**STAFF REPORT - DESIGN REVIEW E
FINDINGS AND RECOMMENDATION**

FILE NUMBER: DRE/FSP 19-26000322 - Stark Street Apartments

PROPOSAL: Type III Design Review E for the construction of a multi-family development with 82 units in four buildings, associated parking, and site improvements, and a Type II Future Street Plan.

FIGURE A.

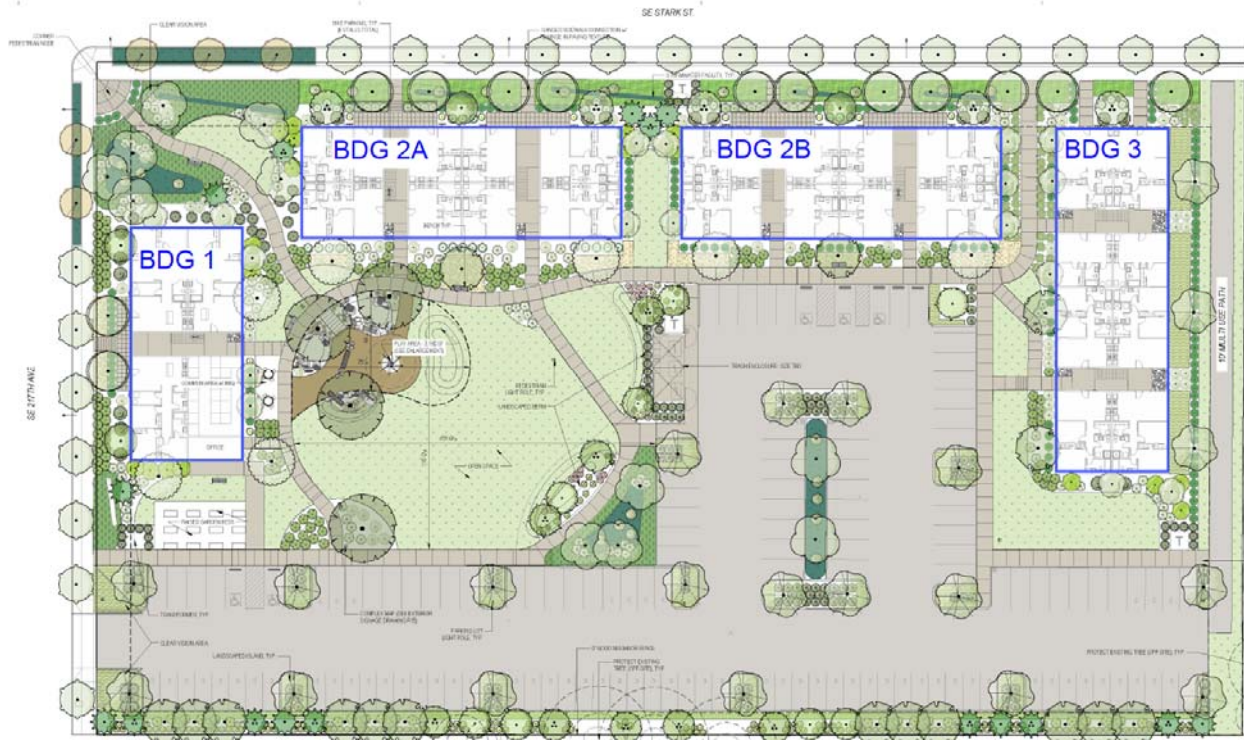
STANDARD: At least 50 percent of the site’s frontage (not including access driveways) on any street shall be occupied by buildings oriented to the abutting street...

PROPOSAL: The site contains 271 linear feet of frontage on SE 217th Avenue, exclusive of the access drive (see Figure A for building numbers). Building 1 occupies 104 linear feet, or 38 percent, of the frontage. There is 505 linear feet of frontage on SE Stark Street. Building 2A, 2B and 3 occupy 332 linear feet, or 66 percent, of the frontage.

FIGURE B.

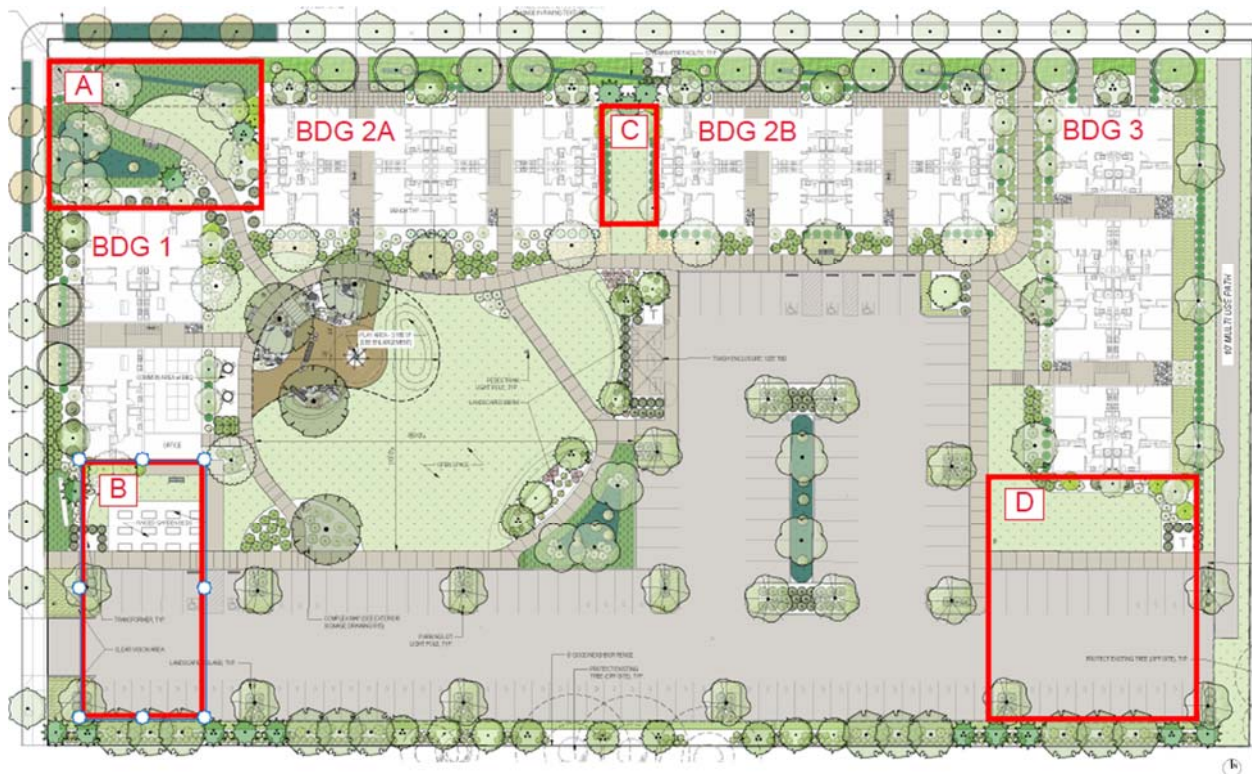
The standard is not met for four common areas. The percentage of units with living or kitchen windows overlooking the common areas are as follows (see Figure B):

- A. The common space and walkway north of Building 1: 0 percent
- B. The community garden beds, walkway and parking south of Building 1: 0 percent
- C. The lawn between Building 2A and Building 2B: 0 percent
- D. The common area south of Building 3: 0 percent

RECOMMENDATION: There are four common areas that are not visible from any frequently used room as defined in this standard (A-D as shown in Figure B). The standard for 50 percent of units to overlook these common areas is not met. Area C is located in the center of the site and access is exclusively provided from an internal walkway; therefore, it is reasonably controlled. This area meets the guideline.

Areas A, B, and D are located on the edges of the site and with open access from the street or the multiuse path. These areas do not meet the guideline. The narrative has also not proposed a waiver based on a particularly creative aspect of the proposal. Staff recommends that with the building permit the applicant submit revised floor plans demonstrating that at least 50 percent of units adjacent to the following areas contain at least one window of a frequently used room overlooking that area: the common space and walkway north of Building 1, the community garden beds, walkway and parking are south of Building 1, and the common area, walkway and parking area south of Building 3. Frequently used rooms include kitchen, living rooms and dining rooms, but not bedrooms or bathrooms. The design shall be approved by the Manager. Should the revised design reflect visibility from less than 50 percent of units, then it shall be reviewed by the Design Commission.

Standard Arterial

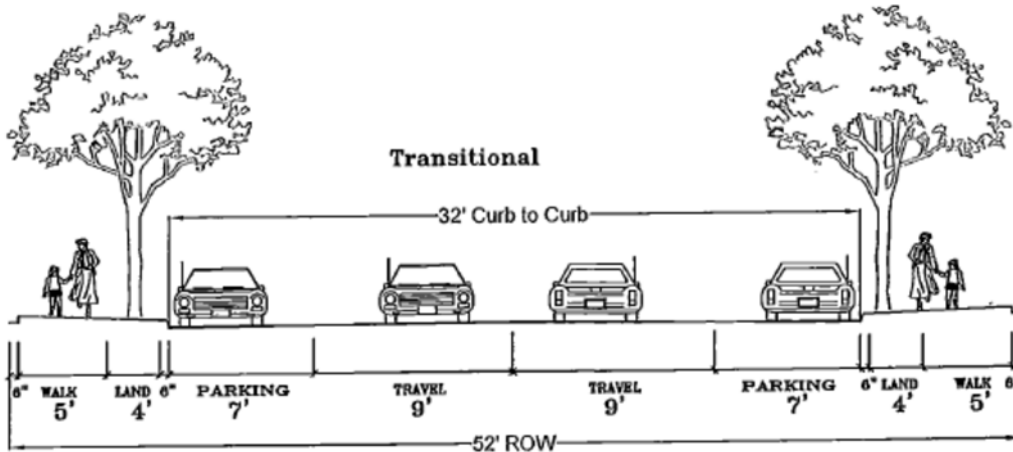
The applicant is showing in the drawings an 8-foot dedication on SE Stark Street, which meets the standards.

SE 217th Street is classified as a Local Transitional Street requiring 52 feet of right of way and 26 feet to centerline. SE 217th Avenue is already dedicated to 60 feet and requires no further dedication. A Transitional Street cross section is shown below to inform the frontage needs.
